Cumberland County Subdivision and Land Development Review Report

Plat Title: Woods of Barnitz Lots 7 & 8 and 48-52

Plat Status: Final Plat Type: Subdivision

FINAL CONFIGURATION OF PROPOSED LOTS

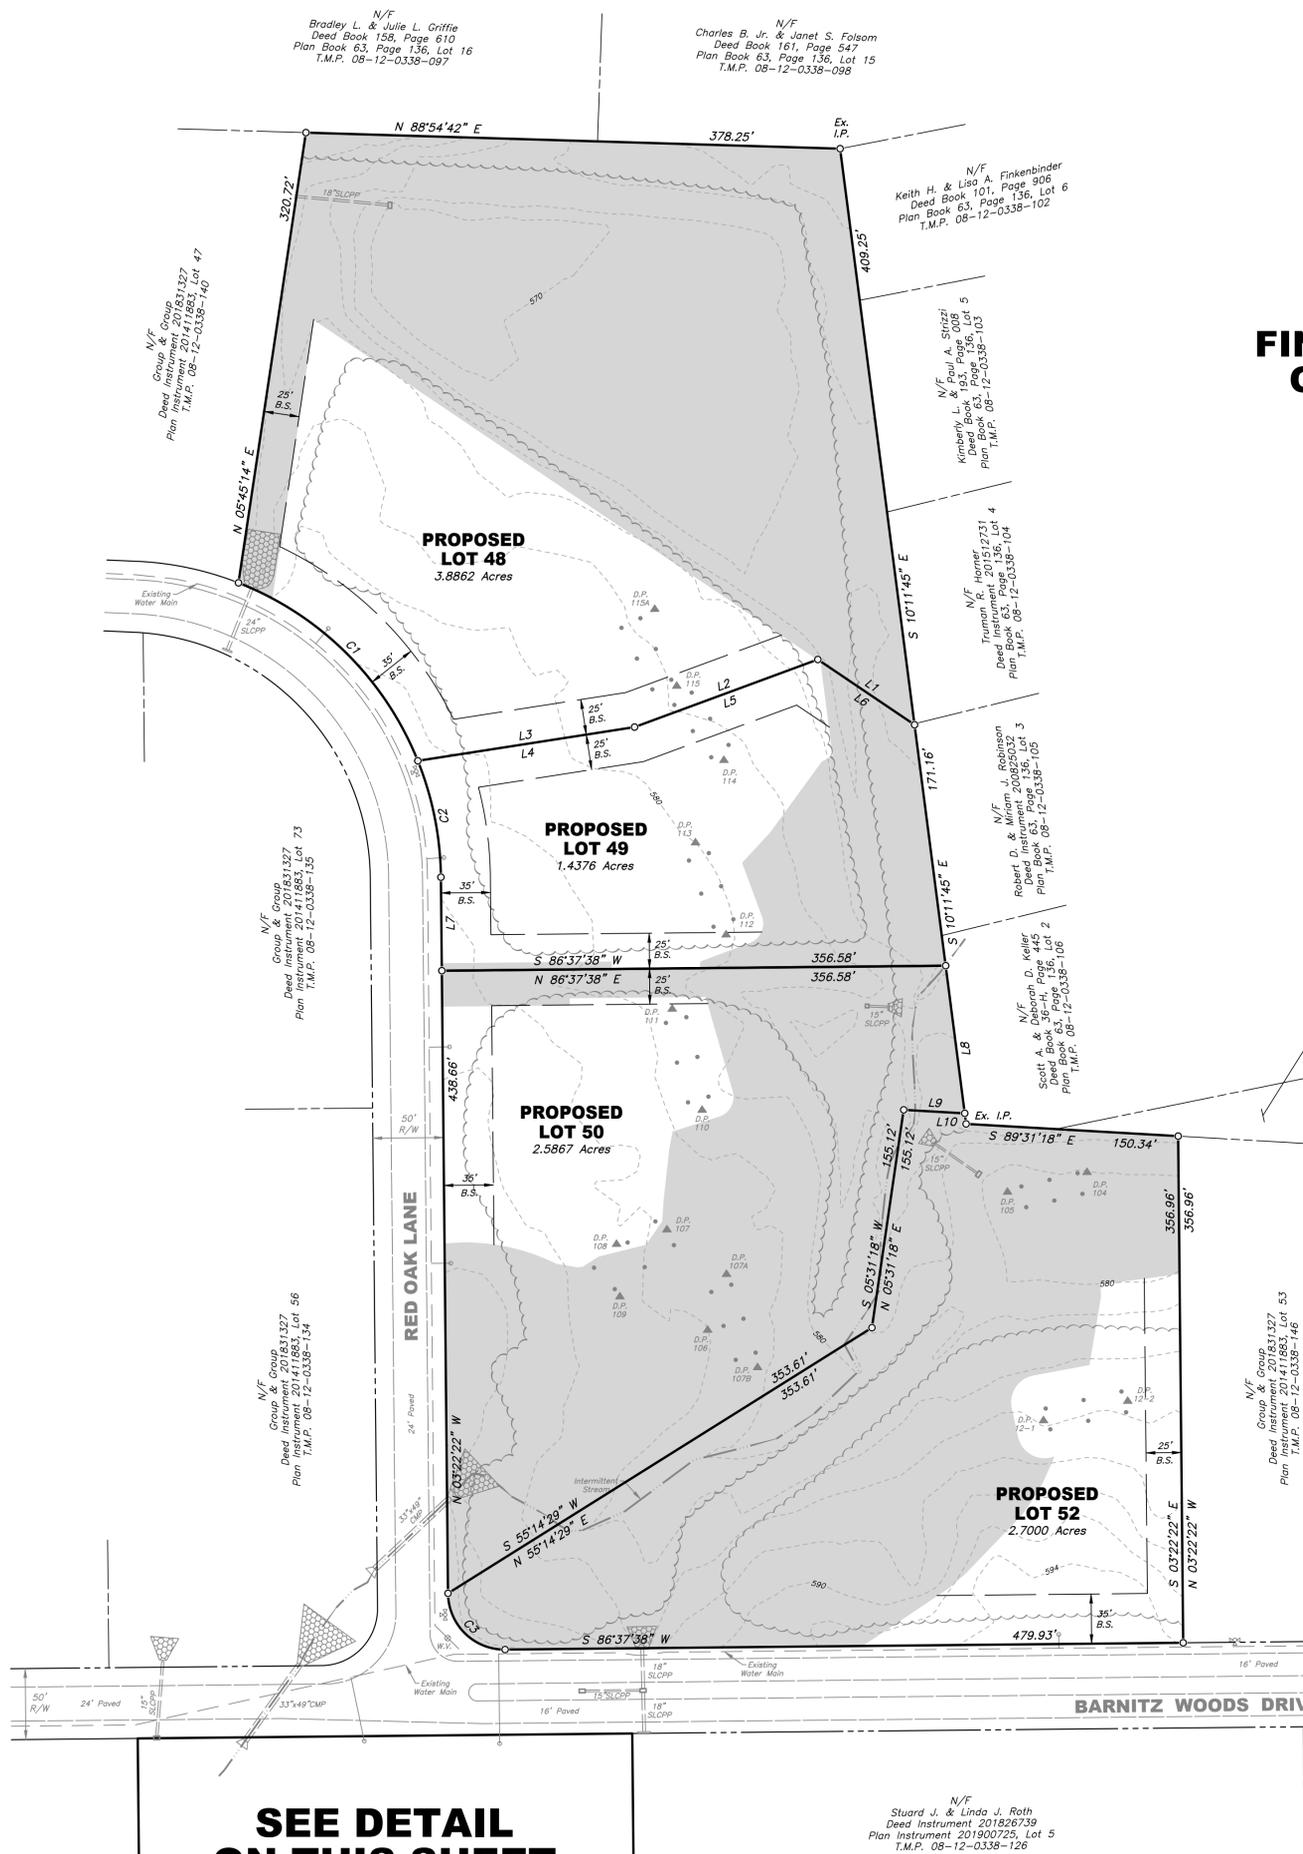
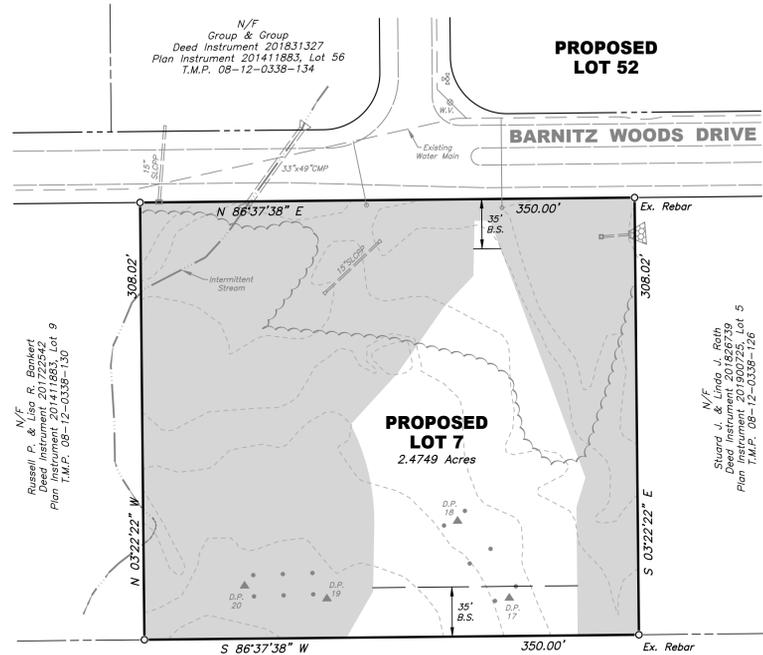
1. The location of the reserve drainfield for Proposed Lot 48 appears to be the reserve drainfield location for Proposed Lot 49. This drainfield appears to cross the property line. The township should determine whether another location is needed to provide a backup site for each lot.

2. Provisions for reserve drainfield locations for Proposed Lot 7 and Proposed Lot 8 should also be addressed in the plan.
3. The plan should address DEP Sewage Facilities Planning Module requirements.
